Sewerage & Water Board of NEW ORLEANS

Addendum No. 2

Your reference is directed to **Contract 1415 – CARROLLTON WATER PURIFICATION PLANT WEST POWER COMPLEX FOUNDATIONS AND UNDERGROUND UTILITIES** for the Sewerage and Water Board of New Orleans which is scheduled to open at **11:30 a.m. Local time on February 1, 2023.**

Questions and Responses During Bidding

C8 FRENCH DRAIN DETAIL

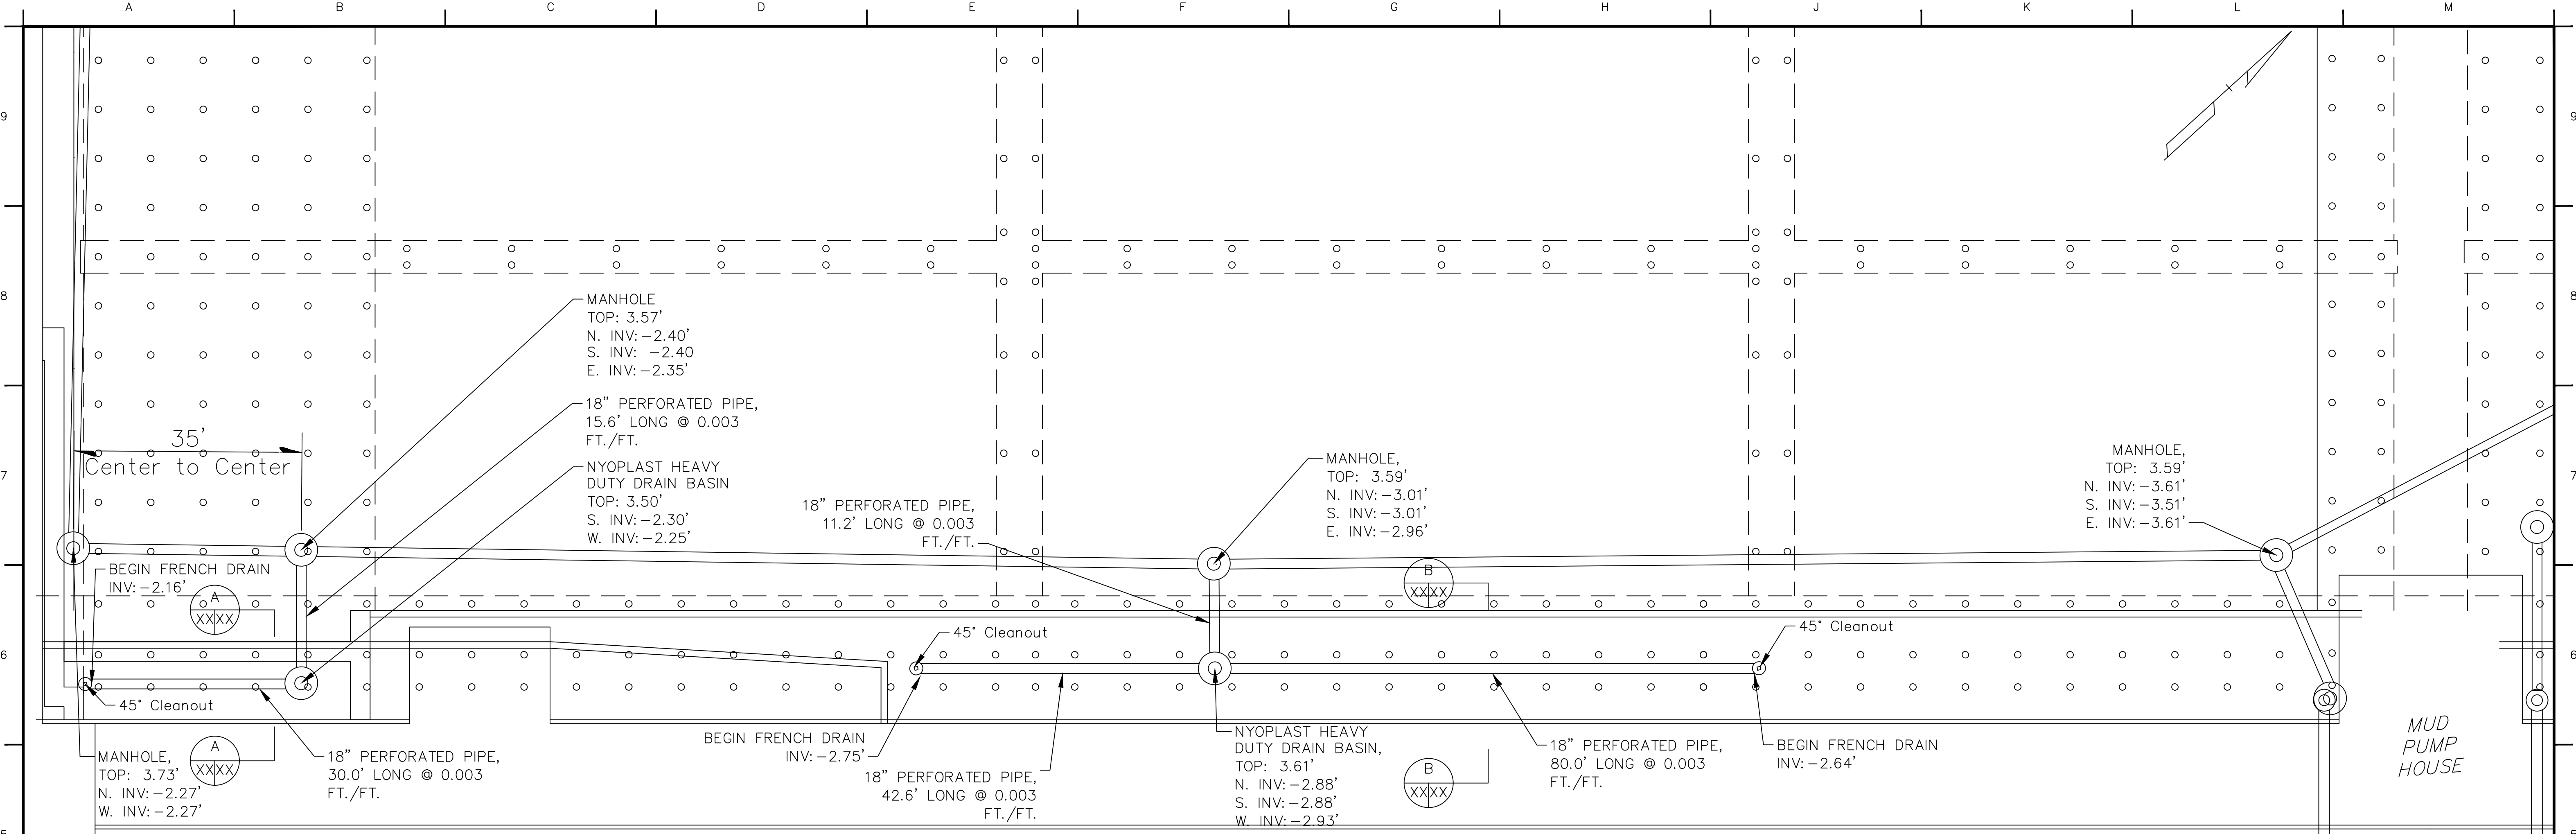
- a. Attachment 1 – C1415 Questions and Responses During Bidding – Version 0, Dated January 11, 2023 [Questions 1-22].
- b. Attachment 2 – Reference drawing "C8 French Drain Detail" from Contract 1403

RESPONSE #12	As noted on the Technical Specifications Table of Contents, Specification Section 26 05 13 Medium Voltage Cable is provided for reference only.
BIDDER QUESTION #13	Section 01 31 13 Project Coordination Paragraph 3.04B states that C7/C8 site expectations should be that water will be leaking from C and L basins. How much water should be anticipated and how can the Contractor be expected to quantify this statement? Can this simply be handled with a couple of 2 inch electric sump pumps?

RESPONSE #13	Drainage improvements have been implemented such that leakage from the C and L basins are not anticipated to impact the work. However, the stormwater design for C7 and C8 includes storage and transportation of storm water in the stratum of lightweight aggregate that was installed during the C7/C8 demolition project. The design groundwater elevation is

<p>-2.0' and is controlled by the outlets from the stormwater detention facilities. During and following major rainfall events, the groundwater elevation is expected to rise above elev. -2.0'. During long periods of no rainfall, the elevation is expected to drop below elev. -2.0. Contractors should expect to deal with groundwater if their operations involve excavation in the vicinity of elev. -2.0. Please note Volume 4, Standard and Reference Drawings, Contract 1403 drawings, as well as the additional reference drawing "C8 French Drain Detail" attached to this Addendum 2.</p>
BIDDER QUESTION #14	Can you please provide the Estimate for Job Carrollton Water Purification Plant West Power Foundations & Underground Utilities?
